**Proposed Development of Curraghinalt Mine
Response to NIEA letter of 20th December 2021; Ref: AIL/2020/0105, AIL/2020/0106**

NIEA issued by letter of 20th December 2021 to DGL a Further Information Request under the Water (NI) Order 1999 and the Abstraction and Impoundment (Licensing) Regulations (NI) 2006 related to:

- AIL/2020/0105: Surface Water Abstraction Licence Application
- AIL/2020/0106: Groundwater Abstraction Licence Application

Figure 1: Inflows to Underground Mine from abstraction licence application and July 2020 water balance – groundwater model predictions, with highest total (used in abstraction licence application) highlighted by red circle

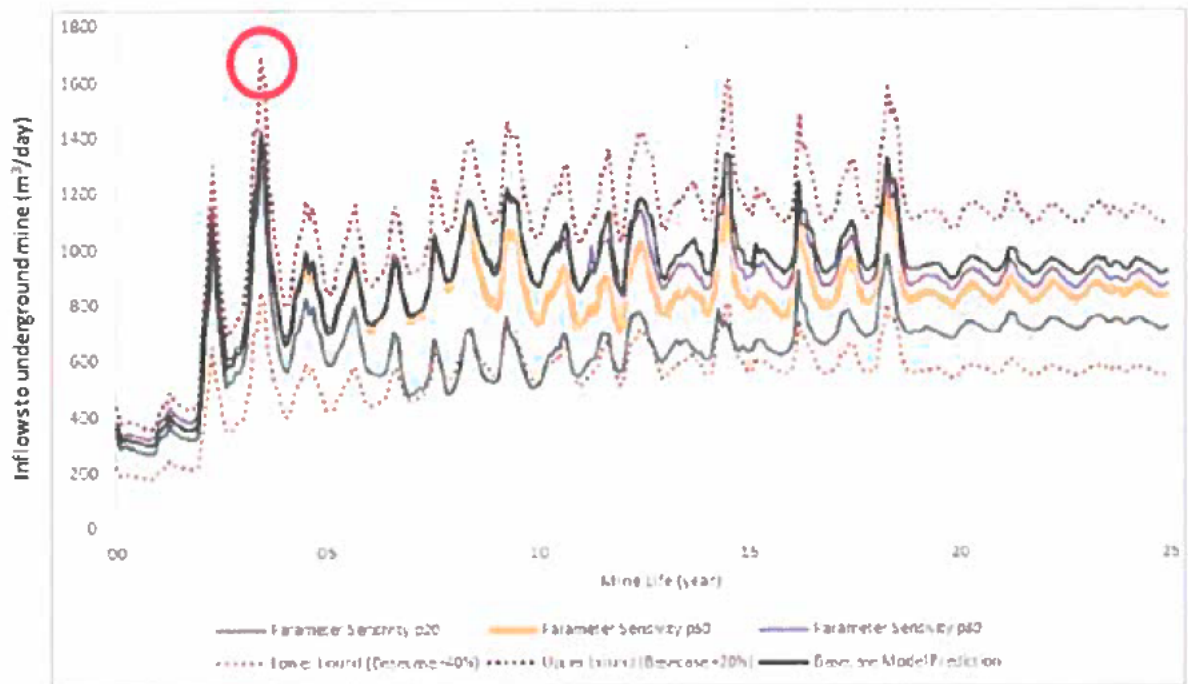
- 1. Please confirm the actual volumes proposed for abstraction for both applications AIL/2020/0105 and AIL/2020/0106. Please provide a detailed schematic drawing of the full proposal setting out clearly the volumes for abstraction, storage volumes and finally discharge. NIEA recognise that these details may have been submitted previously however a range of figures have been provided, as such the information provided in response to this information request will be considered the final volumes proposed for abstraction.**

Abstractions will vary month by month depending on the stage of the mine life and the rock type. The abstraction figure of 1,700 m³/day used in the application refers to the maximum value predicted from groundwater modelling of water flowing into the underground mine. The Environmental Impact Assessment (EIA) for the project included groundwater modelling which considered a range of climatic conditions and other model parameters, producing a range of predictions for water entering the mine workings. The range of values are summarized in Figure 1, which was provided within the Abstraction Licence application documents.

Figure 1 illustrates how mine water inflows and abstractions would vary through the life of mine. The value in the abstraction licence application is illustrated in Figure 1 with a red circle. The value in the abstraction licence is the maximum predicted volume of 1,700 m³/day (70.8 m³/hour or 19.7 L/s). Within the October 2020 Water Balance Report the groundwater modelling was updated. Following this update the maximum discharge reduced to 1,610 m³/day. We are content to retain the maximum discharge rate of 1,700 m³/day, as per the application, given the small difference (5%) in values.
